**ENGINEERING EVALUATION / COST
ANALYSIS FOR ARSENIC IN SOIL
VOLUMES I, II and III
SPRING VALLEY OPERABLE UNITS 4 AND 5
WASHINGTON, D.C.**

**CONTRACT DAHA90-94-D-0010,
TASK ORDER DA01
DERP-FUDS HTRW PROJECT
NO. C03DC091802**

ENGINEERING EVALUATION / COST ANALYSIS FOR ARSENIC AND OTHER SELECTED CHEMICALS IN SOIL (JULY 18, 2003 DRAFT-FINAL)

**SPRING VALLEY OPERABLE UNITS 4 AND 5
WASHINGTON, D.C.**

Figure 3-3
Grid Sampled Sites

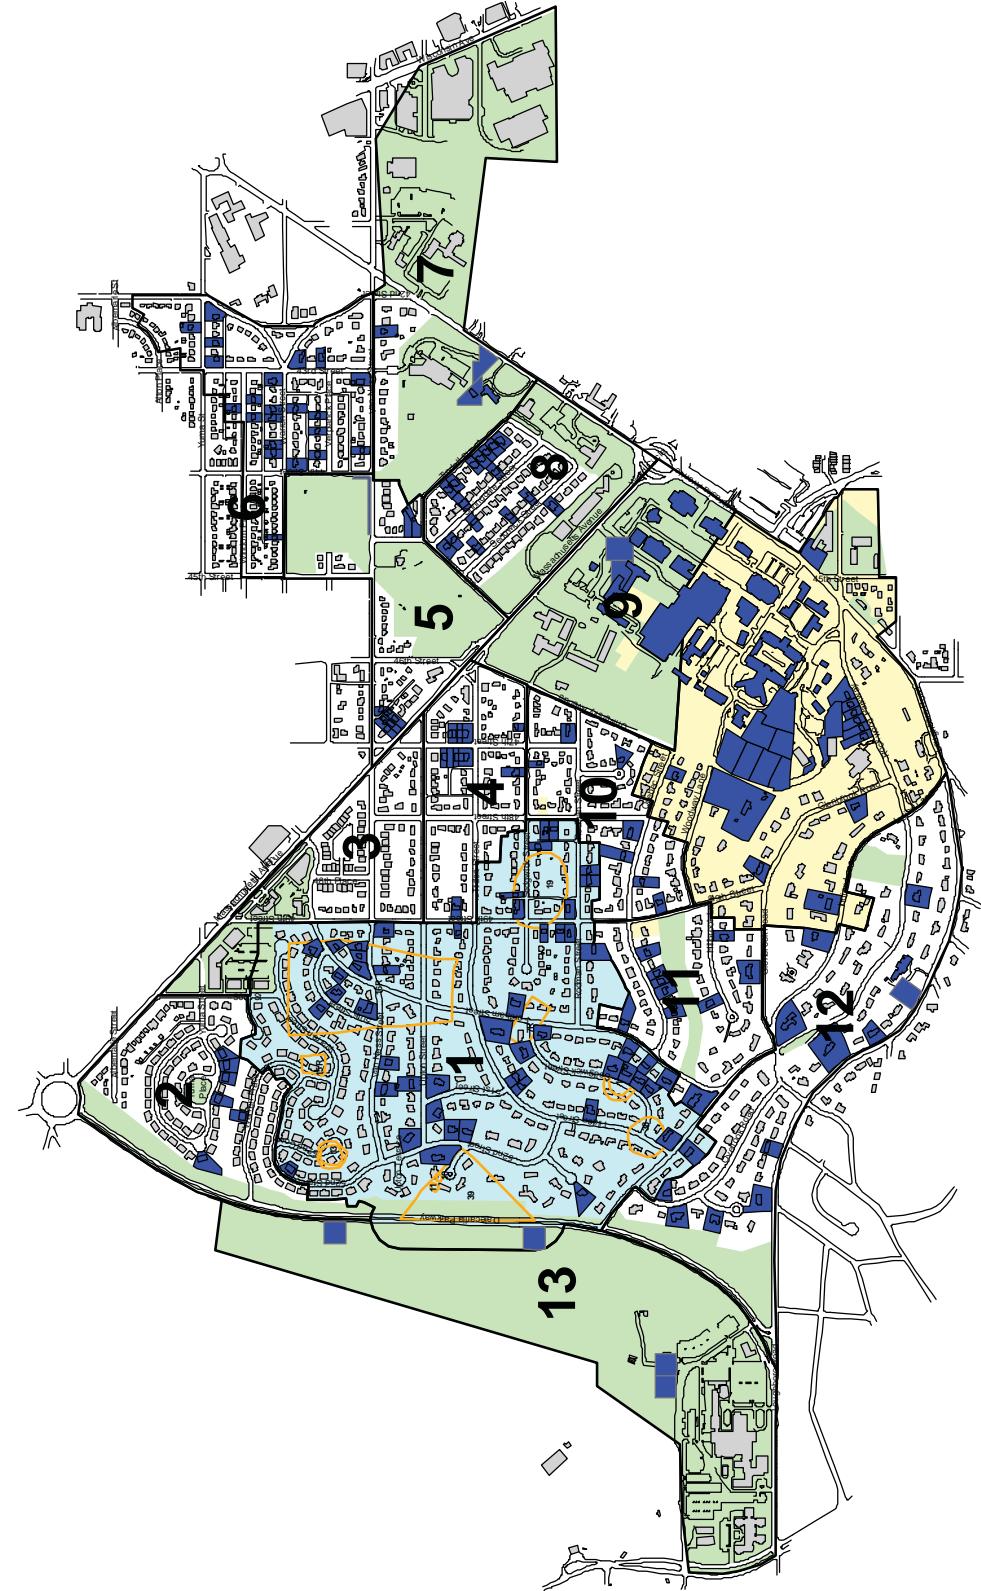
No.	Name	Comment and Response
7.	DCDOH	<p>7) Figure 3-3. Excellent aid. Suggest adding, “ > 12.6 ppm to definition of blue block.</p> <p>RESPONSE: Figure 3-3 has been revised to indicate that a site needed to exceed the 12.6 ppm arsenic screen in order to be grid sampled.</p>

Figure 4-2
Specialty Parameter Detections
 (Not Including AUES List Sampling)

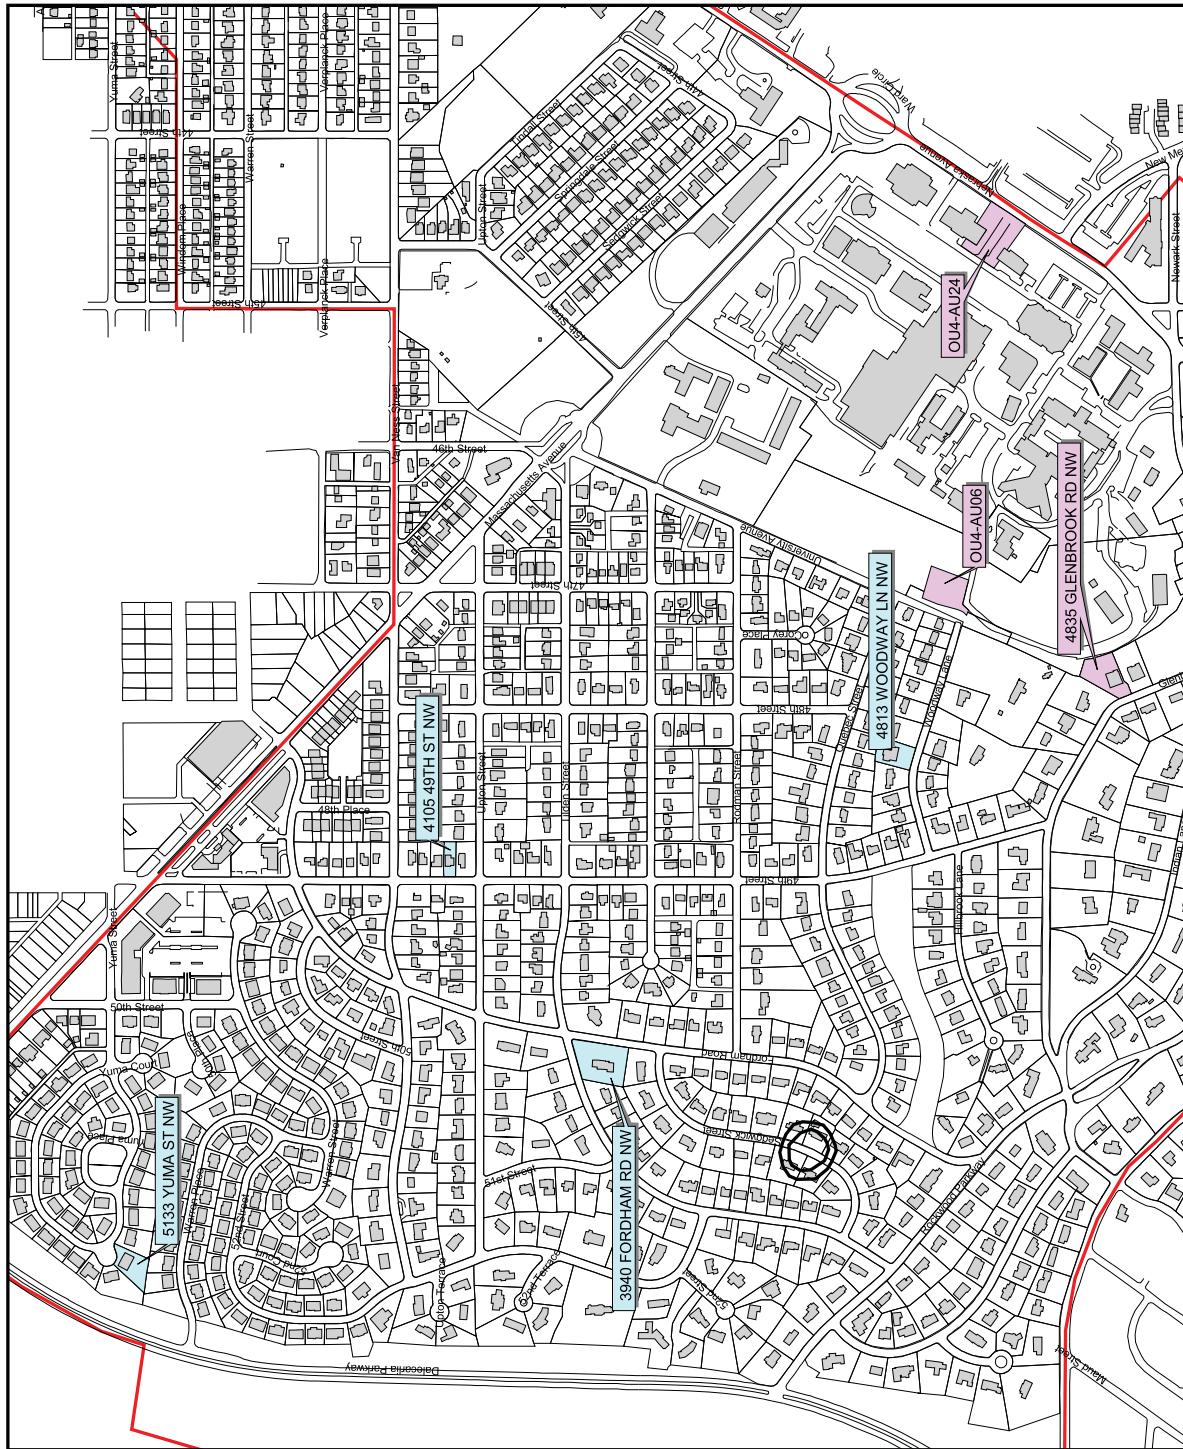
9.	DCDOH	<p>9) Figure 4-2. Excellent aid. Should cover all of current FUDS boundary. Should cover all sample results for the two constituents (possibly using a different color for other sampling efforts). (i.e. thioglycol reading on 4625 Rockwood Parkway and 52nd court trench from CBDA sampling. Cyanide reading at Sedgwick trench). Also recheck Corey Place data.</p> <p>RESPONSE: Generally, data presented in figures in this EE/CA reflect activities performed for the EE/CA. Data from other past sampling events are not shown, to ensure the document does not deviate from its express purpose and objectives. Specifically, Figure 4.2 is described in Section 4.4 as one that presents the EE/CA sampling results <u>other than the AUES list</u>. The 4625 Rockwood thioglycol detection was from the AUES List sampling. Those results will be assessed in detail in another document. No data regarding any non-arsenic detection at a Corey Place residence could be found.</p>
